May 9, 2023

ADDENDUM NO. 1

RE: Item #1, May 17, 2023 Letting - NH 0018(157)438, PCN 6923, Lincoln County - Grading, PCC Surfacing, Asphalt Concrete Surfacing & Replace Str RCBC (2 - 9'x5' Precast or CIP; 2 - 12'x5' CIP RCBC)

| STATE OF SOUTH DAKOTA | PROJECT NH 0018(157)438 | SHEET NO. B67 | TOTAL SHEETS B139 |

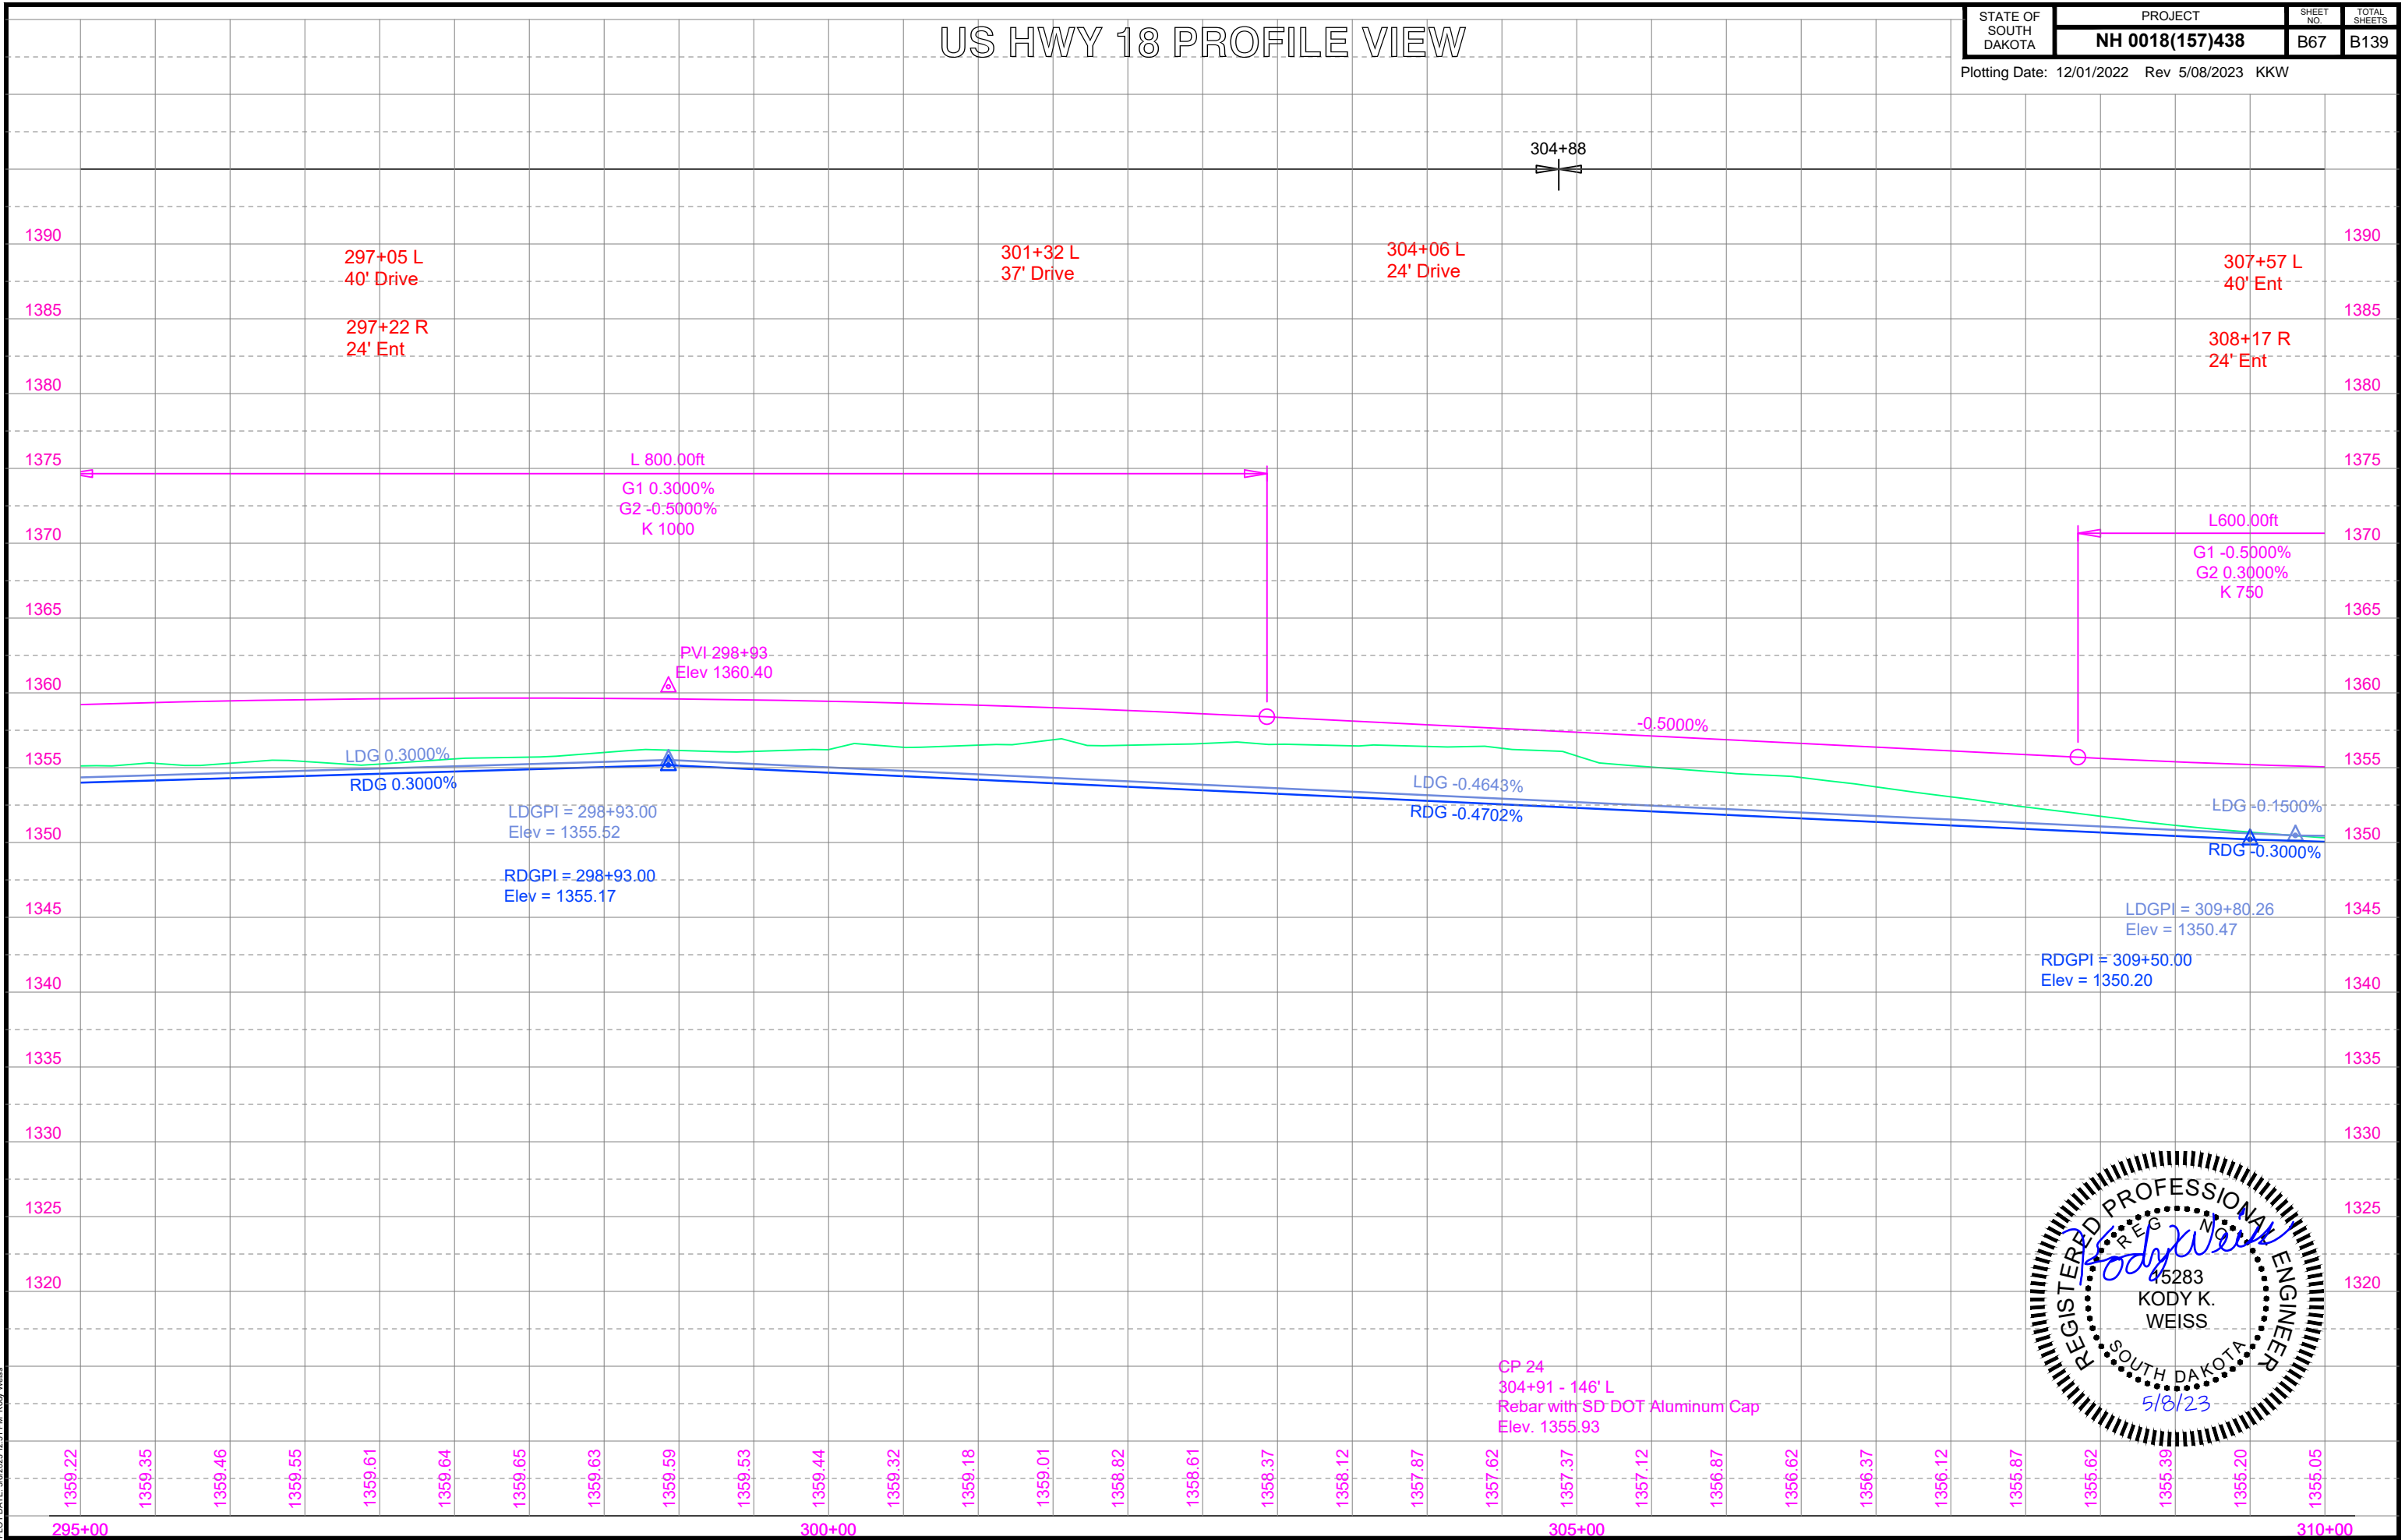
- Sheets B66 & B67:** Added approach at 308+17R, and revised fencing and pipe to accommodate approach entrance.
- Sheets B68-B70:** Fence, curb and gutter and drop inlet adjacent to parcel 33 were revised.

| STATE OF SOUTH DAKOTA | PROJECT NH 0018(157)438 | SHEET NO. B74 | TOTAL SHEETS B139 |

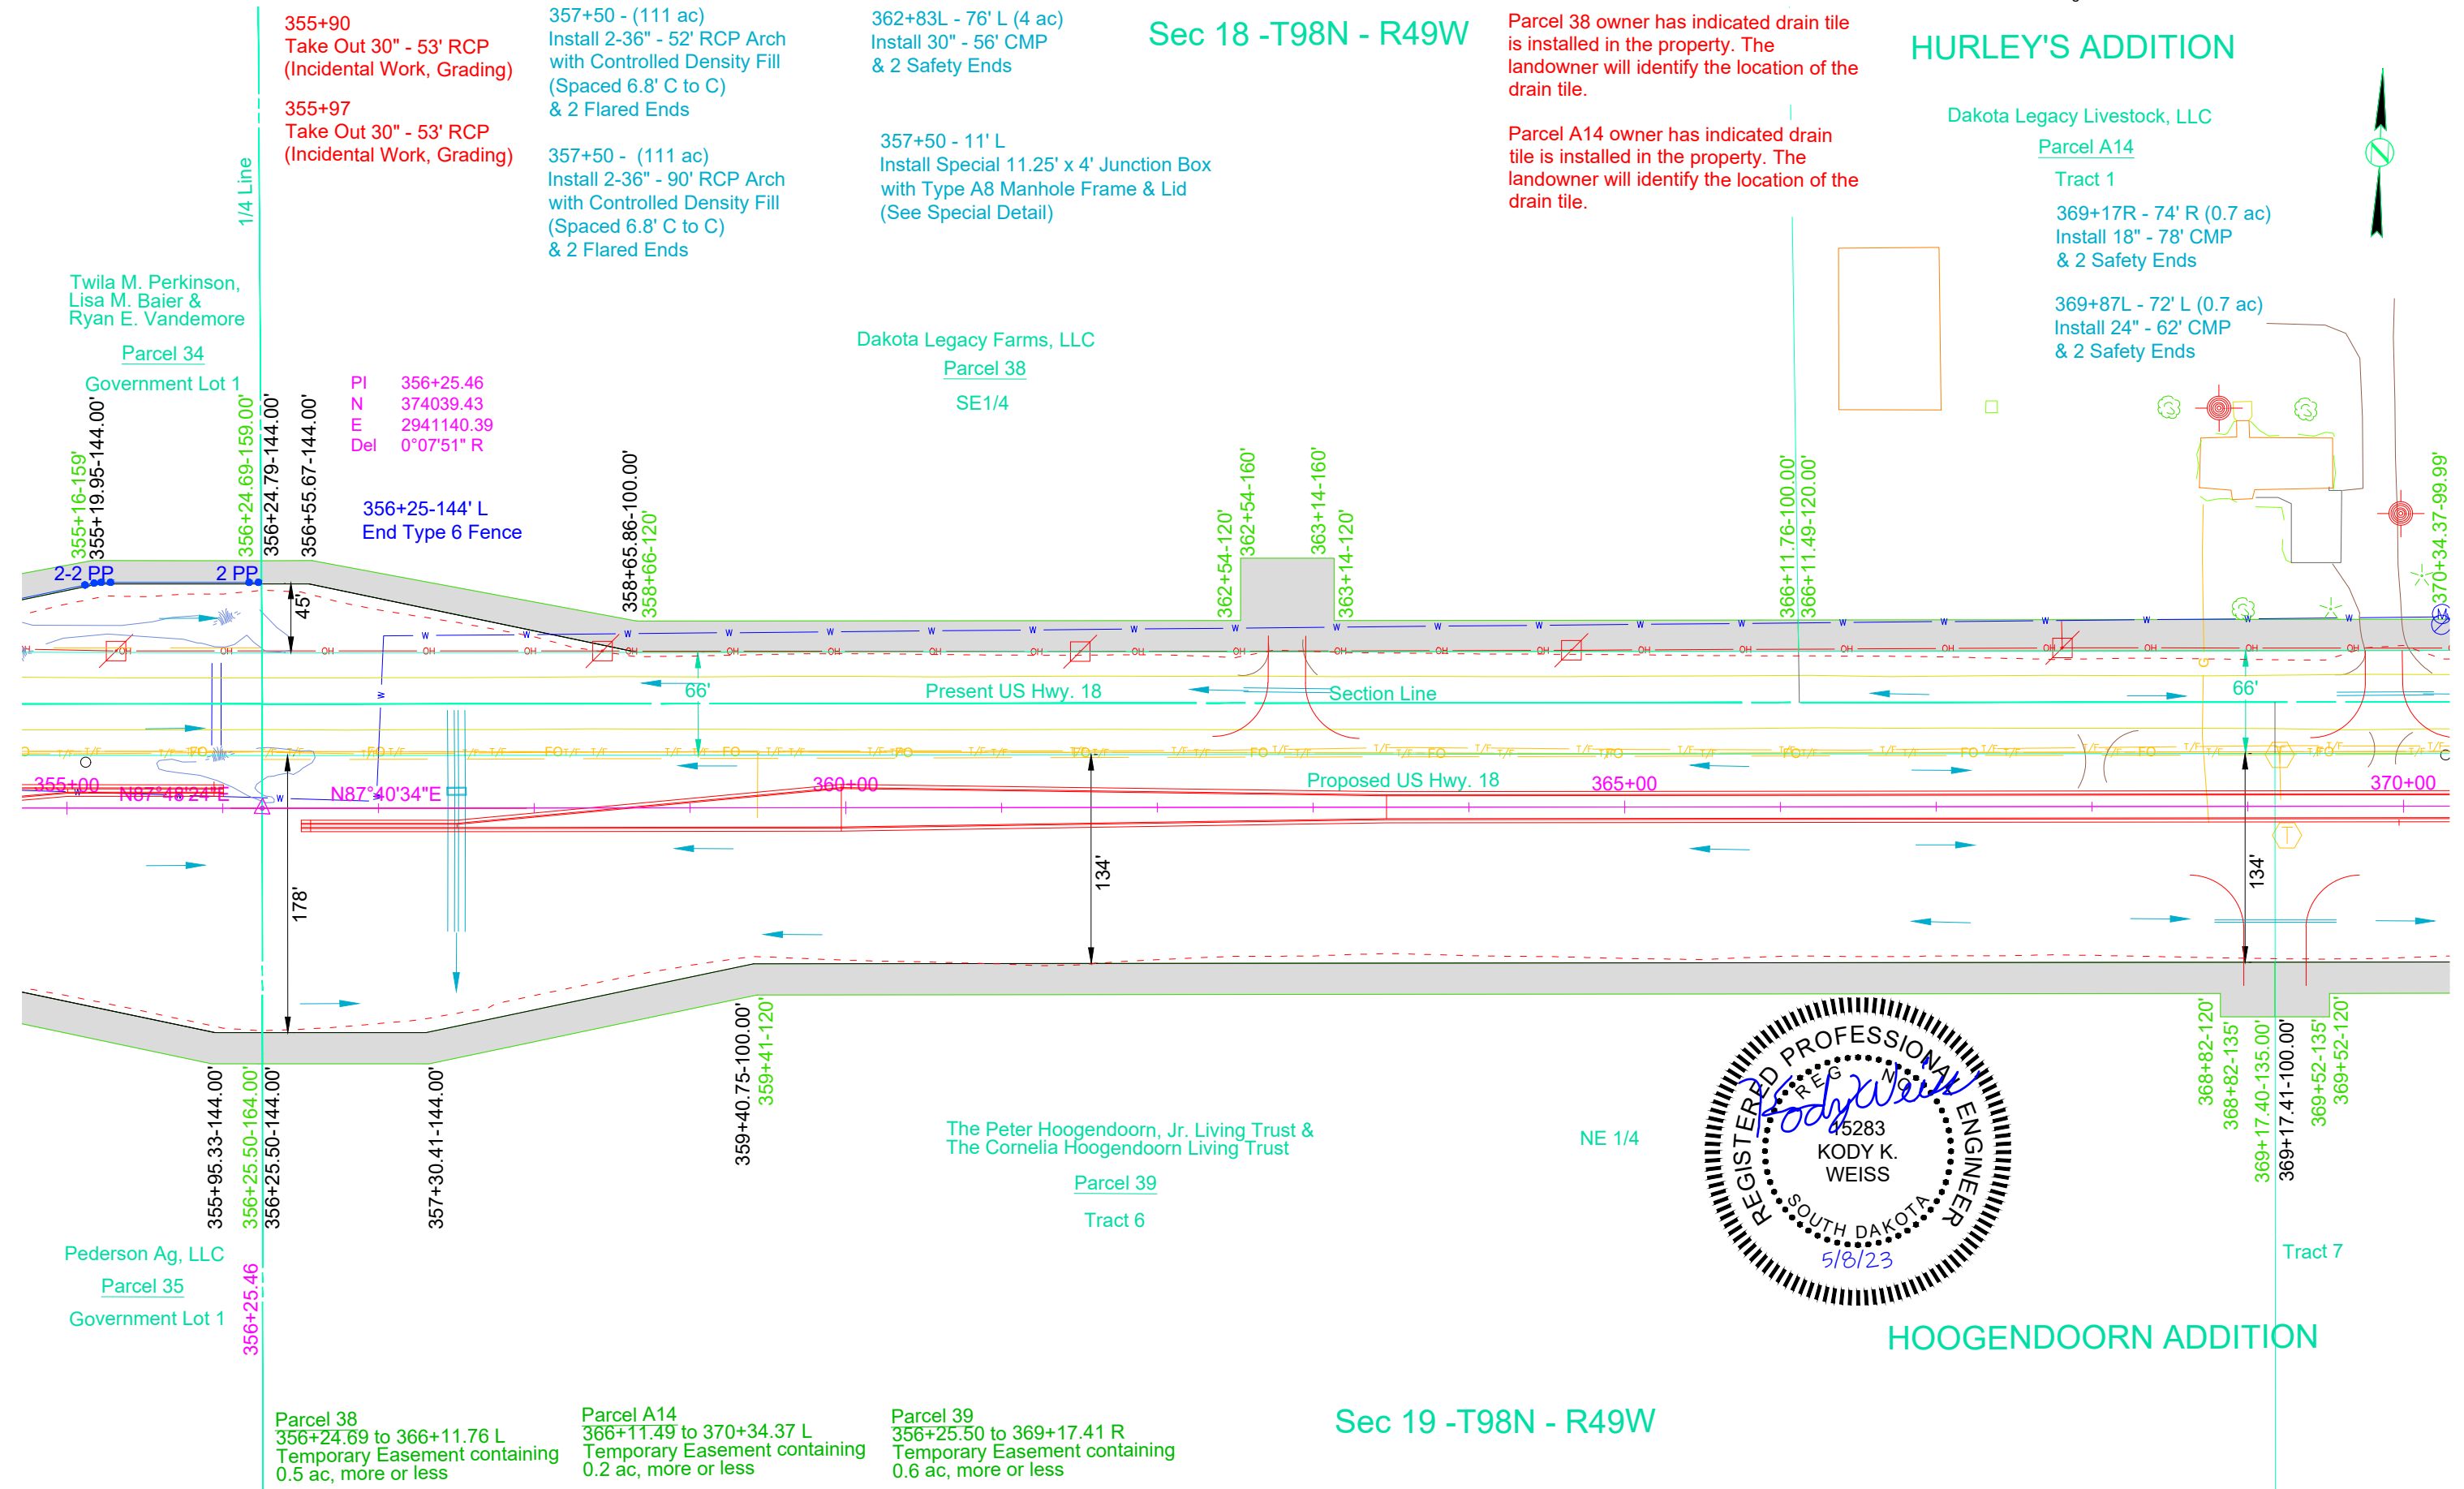
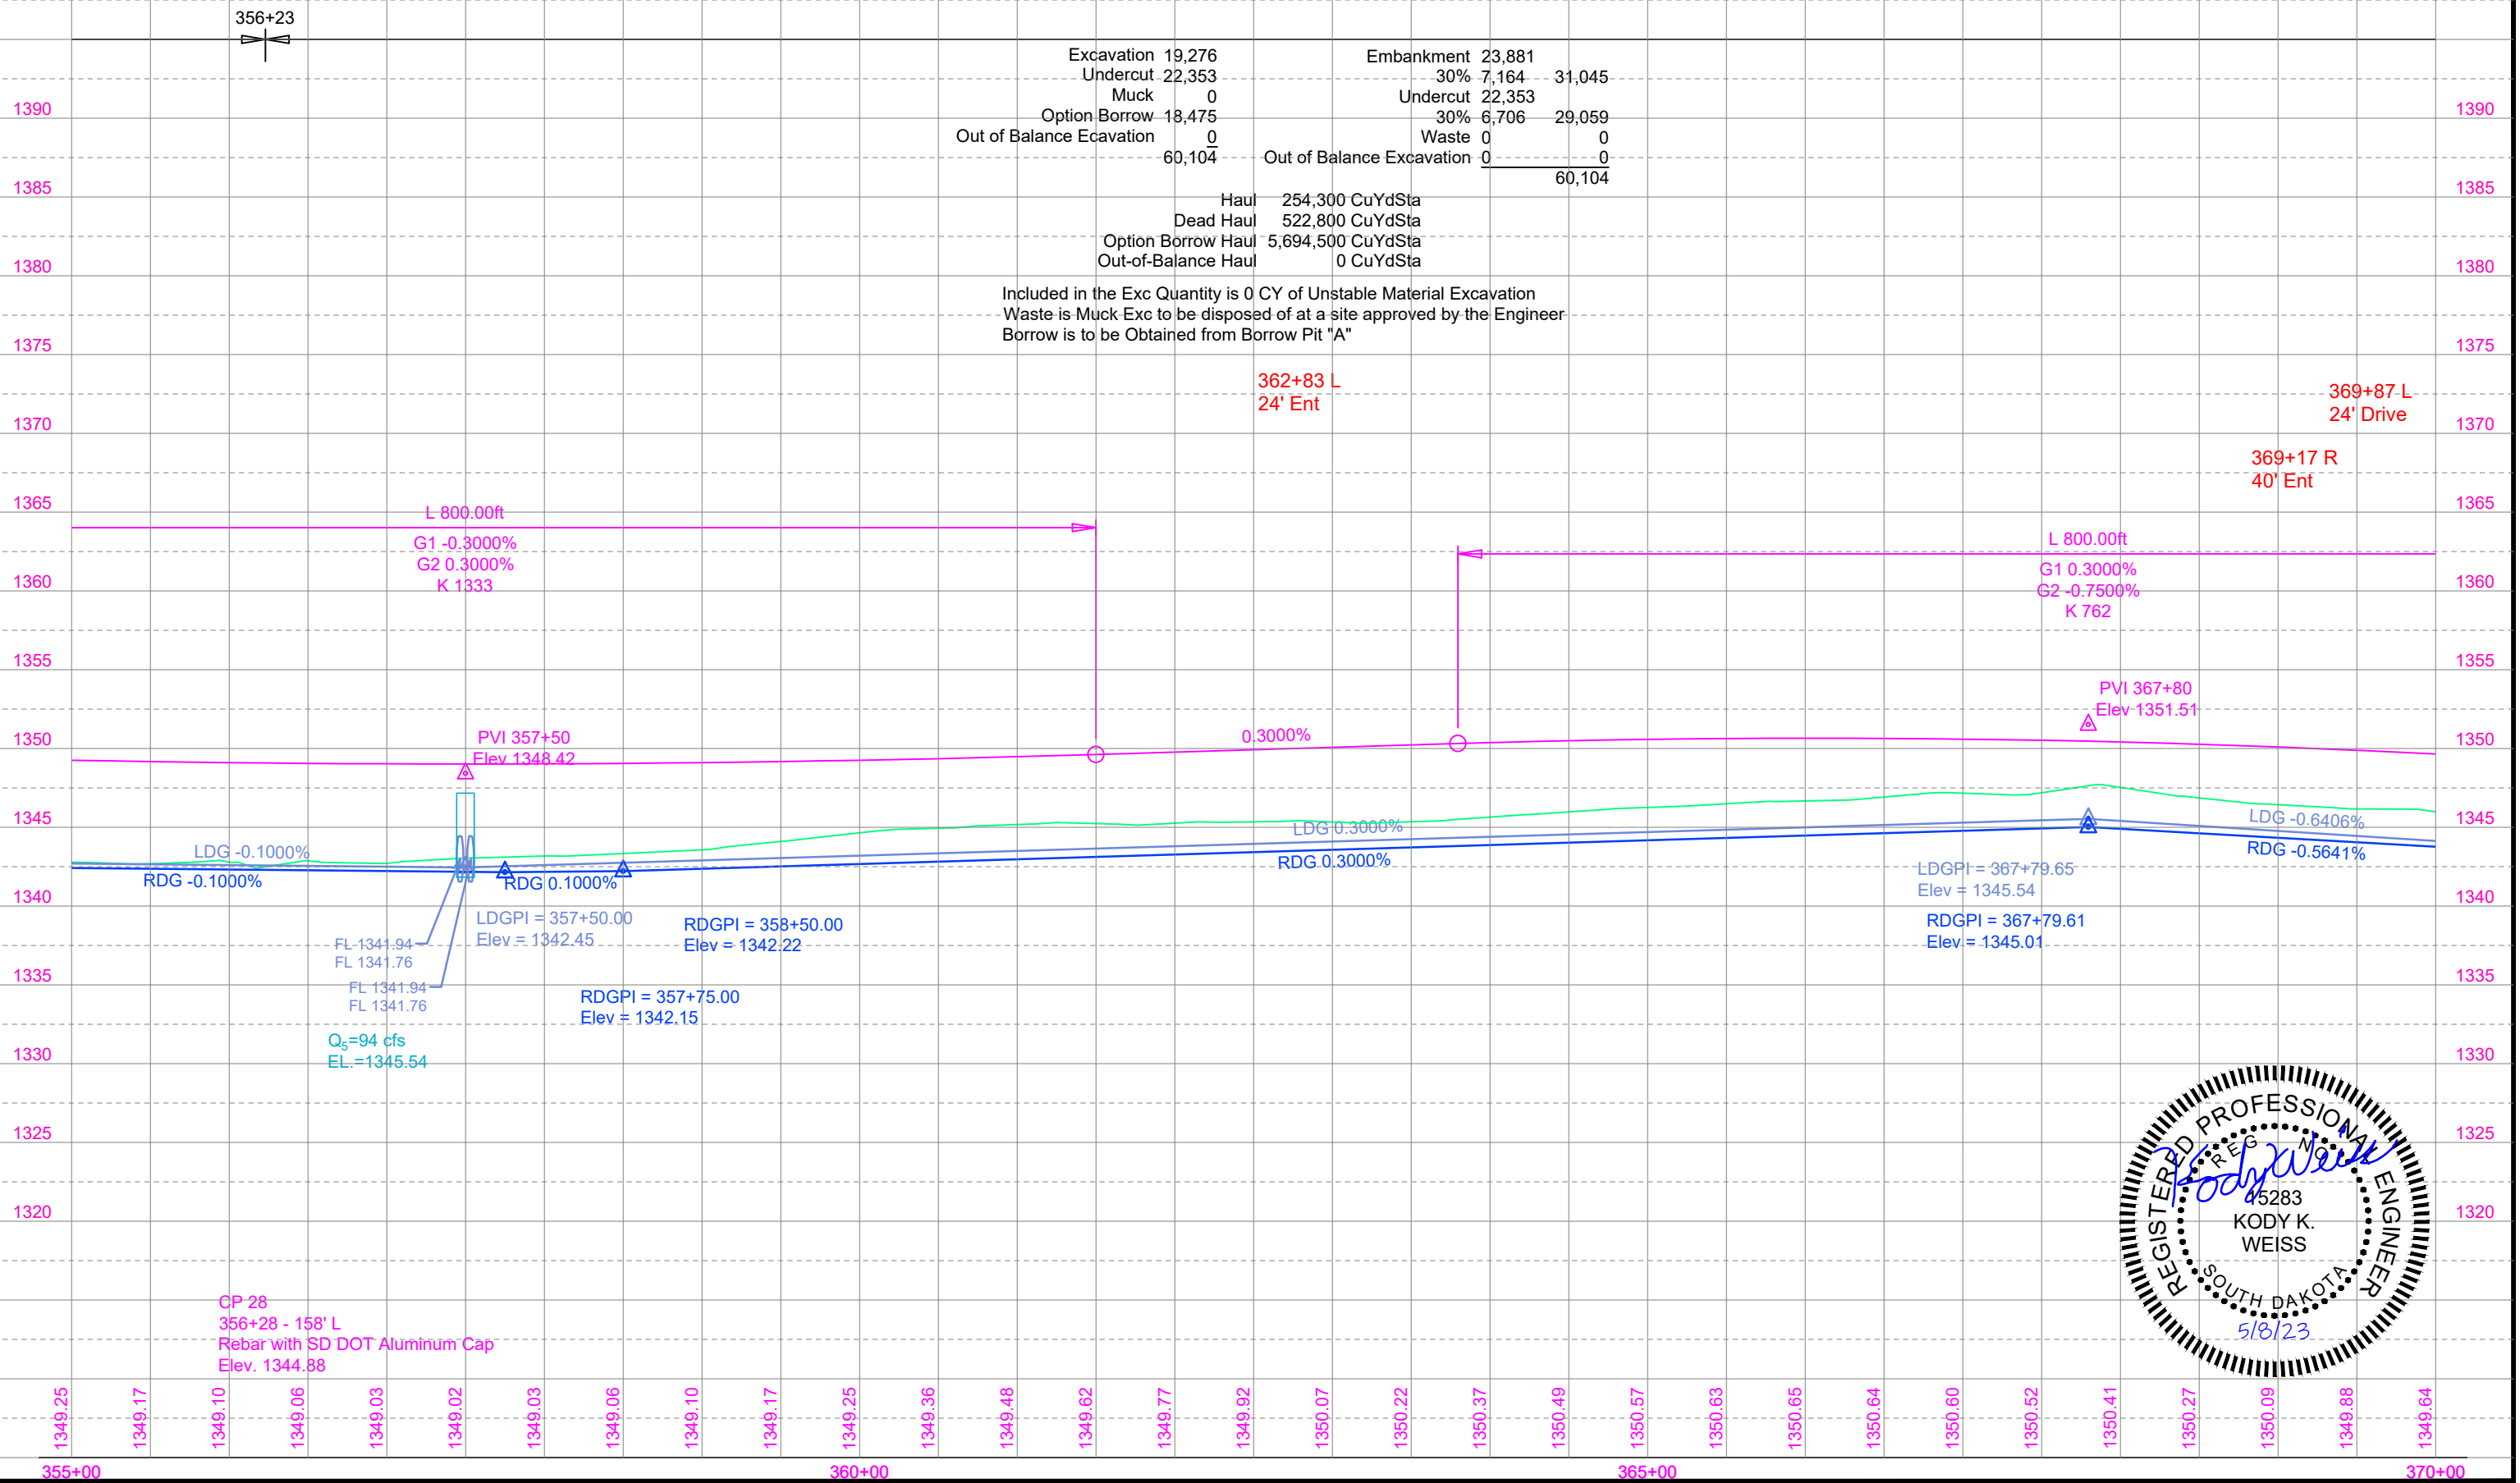
- Sheets B74 & B75:** Sta 357+50 Junction Box was revised.
- Sheets B76 & B78:** Salvage Existing Vinyl Fence and Gate notes were removed.
- Sheets B112 – B117:** Special Junction Box details were revised.
